Item No:	Classification	Committee:	Date:
6	Open	Bermondsey Community Council	9 May 2012
From:		Title of Report:	
Head of Development Control		Addendum Late observations, consultation revisions.	responses, information and

#### 12-AP-0395 29 Curlew Street, London, SE1 2ND

In addition to the letter as above the following photos were submitted which show views from flat 5 Canvas House:

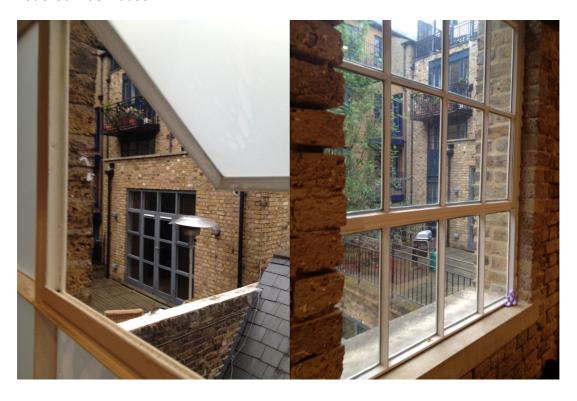
The photos attached are taken from my bedroom window. The existing terrace at number 29 Curlew Street (which is heavily used for entertaining involving large numbers of people) is within touching distance of Canvas House. The proposed alterations and increase in height will obviously have a very significant visual impact and will reduce light to my flat. I don't imagine that any representative of the planning department office has viewed the site from Canvas House. Certainly no one has viewed from flat 5 Canvas House, though the case officer is welcome to do so by appointment.

of the loss of amenity of the occupiers of Canvas House, despite the written objections of most of the occupiers of Canvas House. It is self evident that the overbearing impact of the proposed development will be most acutely felt by the residents of Canvas House.

The proposed front elevation of 29 Curlew Street may be in keeping with the local warehouses but the admits that the rear (which is what will be seen from Canvas House) will be a very modern look and not in keeping with the Victorian warehouses.
